THAMES CROSSING ACTION GROUP

Reference: 21/01883/FUL

Address: Coach Park Pilgrims Lane, North Stifford, Grays, Essex RM16 5UZ

Proposal: Retrospective Planning Application for a Temporary Programme Management Office Facility and Contractors Compound with Related Staff Welfare Facilities for a period of five years

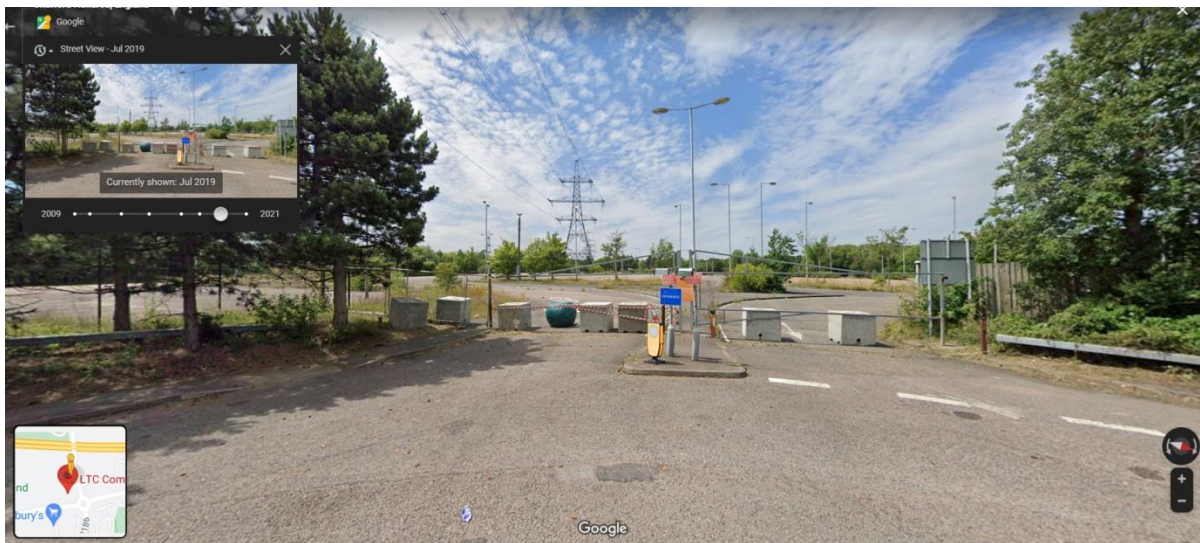
We have serious concerns that the application form states that there are not trees or hedges on the proposed development site.

If there are not trees/hedges on the site then this would indicate that the applicant has removed them as evidence clearly shows there should be.
